Parts Change Information

Subject: Job Separator Bracket			Issue #: 080
New part#: 019-13143-007 New description: Job Separator Bracket EX Old part#: Old description:	Reason for Change ❑ Cost Effective ❑ Eliminate Claims ✓ Easier Operation ❑ Other	Manufacturing Cut-in Serial #: N/A	Applies to: All GR "CE" Models

Part Name:	**Part #**
Job Separator Bracket EX	019-13143-007

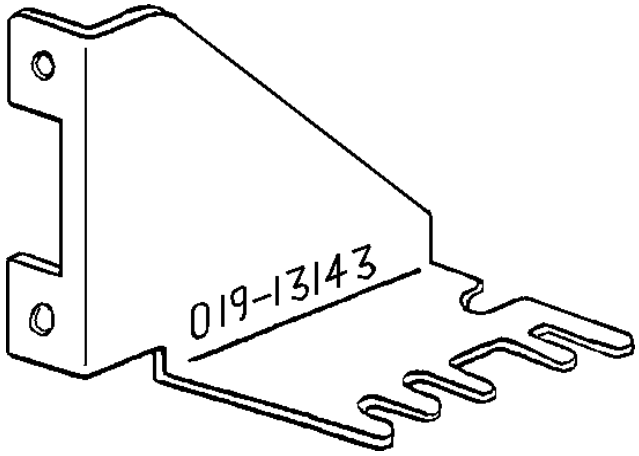
The Job Separator can block the Precision Stacking Tray from closing on "CE" units.

A new bracket is now included with the Job Separator. This new bracket is also available as a separate part. The part number is engraved on the new bracket for easier identification.
